Agenda Item #: 4
SUB-002584-2023

Theodore Veterinary Hospital Subdivision

APPLICATION NUMBER 4 DATE August 17, 2023

DETAIL SITE PLAN

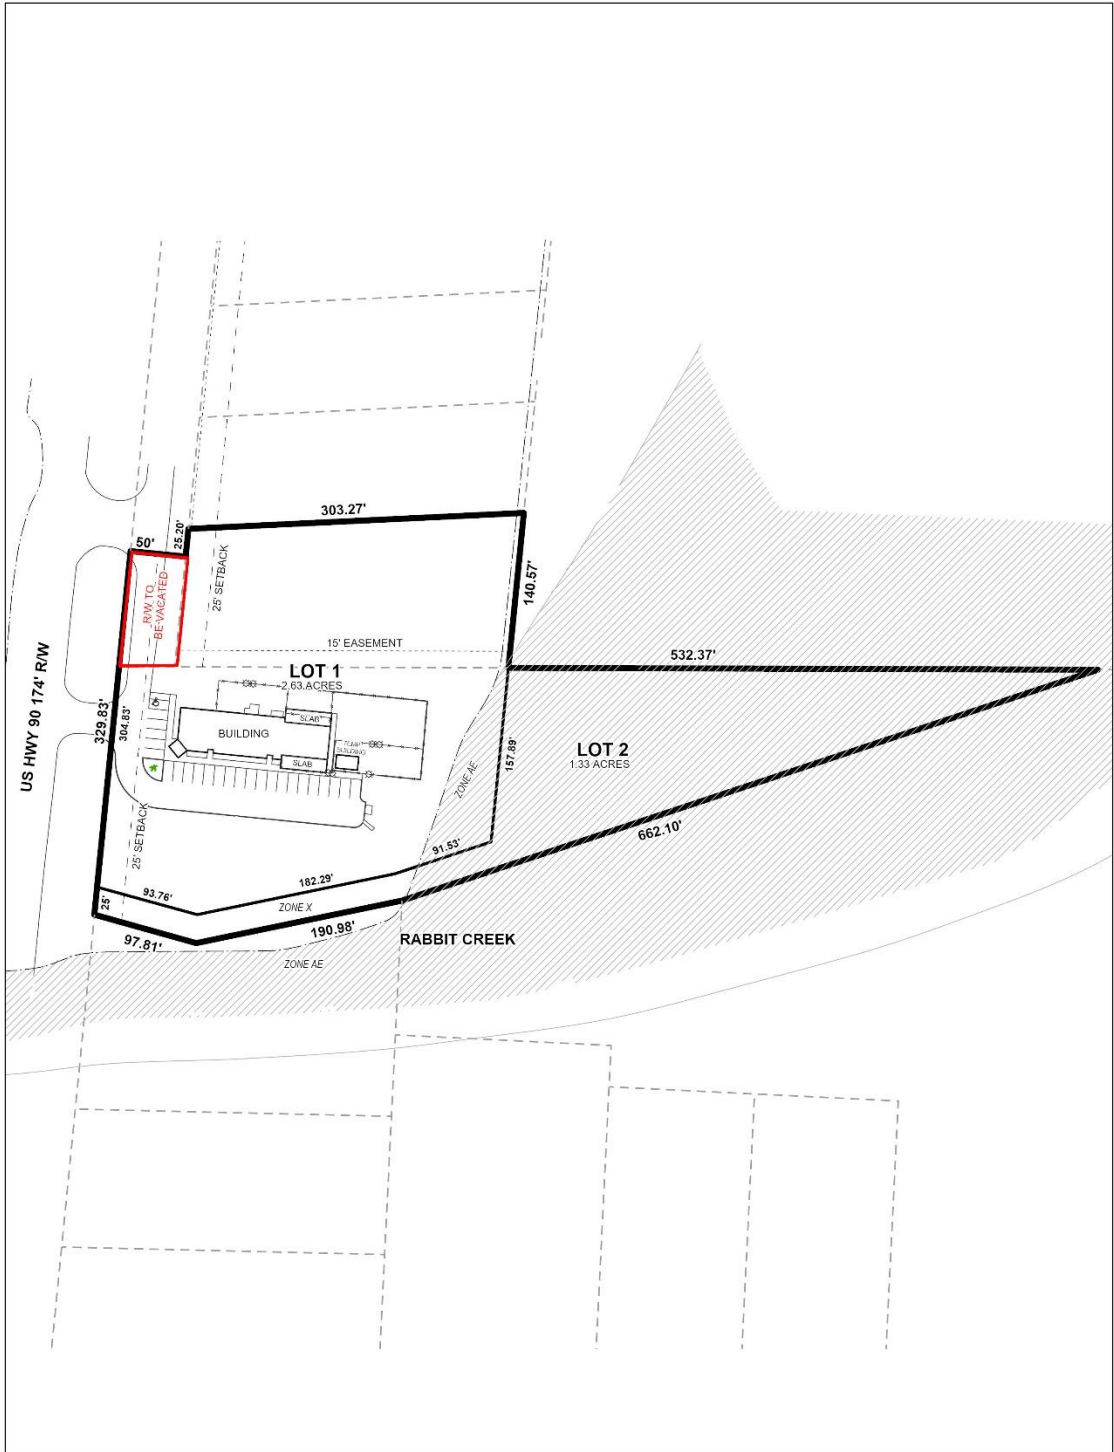
- B. Add E. Rite Rd to the vicinity map.
- C. Show the recording information for the vacated the US Hwy 90 Service Road ROW.
- D. Provide a written description for the proposed subdivision boundary that includes the area of the ROW Vacation.

- E. Show and label the southern proposed property line for LOT 2. It should follow the existing creek centerline as recorded.
- F. Provide a correct designation for each LOT. LOT 1 is labeled twice. Label LOT 2.

- G. The frontage shown for LOT 2 does not provide adequate access to US Hwy 90; it is located behind the existing guardrail along US Hwy 90 and is directly in front of the north wingwall of the existing bridge under US Hwy 90.

- H. Show and label the recorded 80-foot-wide drainage easement (book 508, page 99-100) along the centerline of Rabbit Creek.
- I. National Wetlands Inventory (NWI) mapping, as shown on City of Mobile GIS information, indicates that there is potential for wetlands within the property or properties shown on this plat. Show and label the delineated wetlands, or provide a note stating that the wetlands shown on this plat are scaled from the NWI data and have not been delineated.

- K. Show and label all flood zones. New maps went into effect on June 5, 2020. There is no "X" flood zone; it is either X(S) or X(U).
- L. Add a note to the SUBDIVISION PLAT stating that as shown on the 1984 aerial photo (FLIGHT 21 - #94) LOTS 1 and 2 will receive historical credit of existing (1984) impervious area towards stormwater

Proposed Lot 2 is a flag lot with a 25-foot “pole” extending Eastward into the Lot approximately 380 feet from U.S. Highway 90 West. The preliminary plat illustrates the 25-foot minimum building setback line as measured from the right-of-way line. However, Section 6.C.2(b)(4) of the Subdivision Regulations states that the lot must be a minimum of sixty feet (60’) wide at the building setback line. Therefore, the plat should be revised to illustrate the 25-foot minimum building setback line at a point where the lot is at least 60 feet wide.

The plat indicates a 15-foot drainage easement through proposed Lot 1 which is proposed to be extinguished with the recording of the Final Plat. Not shown on the preliminary plat is a recorded 80-foot wide drainage easement along the centerline of Rabbit Creek. Therefore, the plat should be revised to illustrate this easement. A note should be required on the Final Plat stating that no structure may be placed or constructed in any easement without the permission of the easement holder.

5. Retention of the lot size labels in both square feet and acres, or the furnishing of a table on the Final Plat providing the same information;
6. Revision of the plat to illustrate the 25-foot minimum building setback line on Lot 2 at a point where the lot is at least 60 feet wide;

7. Revision of the plat to illustrate the recorded 80-foot wide drainage easement along the centerline of Rabbit Creek on the Final Plat;
8. Placement of a note on the Final Plat stating that no structure may be constructed or placed within any easement without the permission of the easement holder;
